**Written Submission**

**Royal Society for the Protection of Birds**

**Submitted for Deadline 15**  
**1<sup>st</sup> September 2020**

**Application by Norfolk Boreas Limited for an**  
**Order Granting Development Consent for the**  
**Norfolk Boreas Offshore Wind Farm**

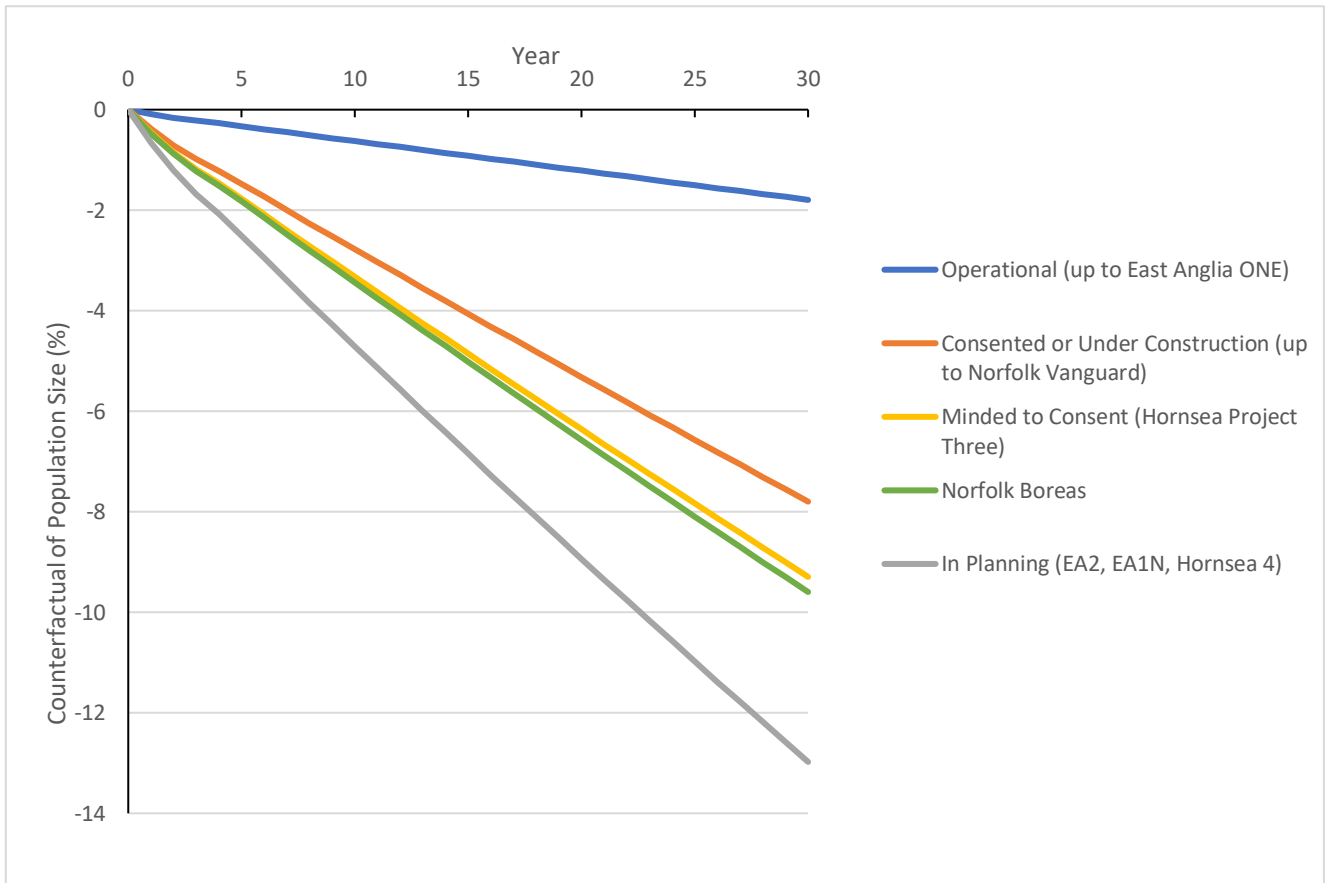
7.18 Figure 3 shows the increases in counterfactual of population size, that is the percentage difference between the impacted SPA population size and the unimpacted population, over each year of the lifetime of the proposed development. Figure 4 shows the increase in the size of counterfactual of population size after thirty years as the cumulative mortality of each development is added.

7.19 These figures, based on the Applicant’s preferred parameters, show a relative **9.6%** reduction in the kittiwake population of the Flamborough and Filey Coast SPA as a result of in-combination collision impacts, in comparison with an unimpacted population, during the lifetime of the wind farms. The RSPB notes that this differs from the figure given in Natural England’s response to the Examining Authority’s Fifth round of Written Questions (Q5.8.6.2, REP14-064), where the

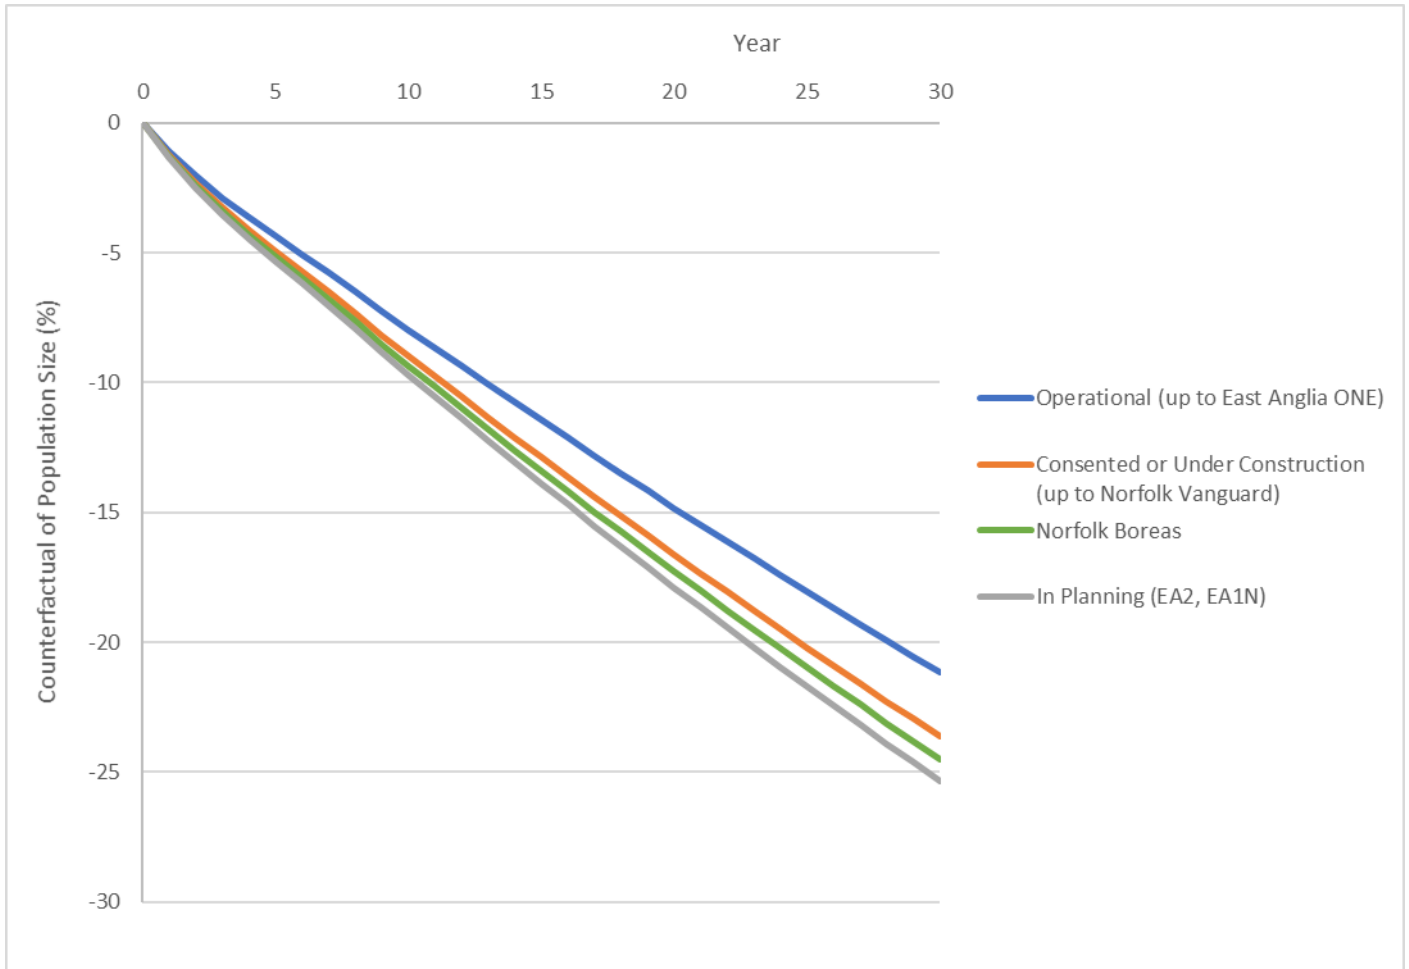
- 7.42 Figure 5 shows the increases in counterfactual of population size, that is the percentage difference between the impacted SPA population size and the unimpacted population, over each year of the lifetime of the proposed development. Figure 6 shows the increase in the size of counterfactual of population size after thirty years as the cumulative mortality of each development is added.

7.43 These figures, based on the Applicant’s own calculations, show a relative **24.5%** reduction in the lesser black-backed gull population of the Alde-Ore Estuary SPA as a result of in-combination collision impacts, in comparison with the unimpacted population, during the lifetime of the wind farms. This demonstrates the addition of mortality arising from Norfolk Boreas to the in-combination impacts on the lesser black-backed gull feature of the Alde-Ore Estuary SPA causes a further deterioration from its current unfavourable population level and makes it increasingly
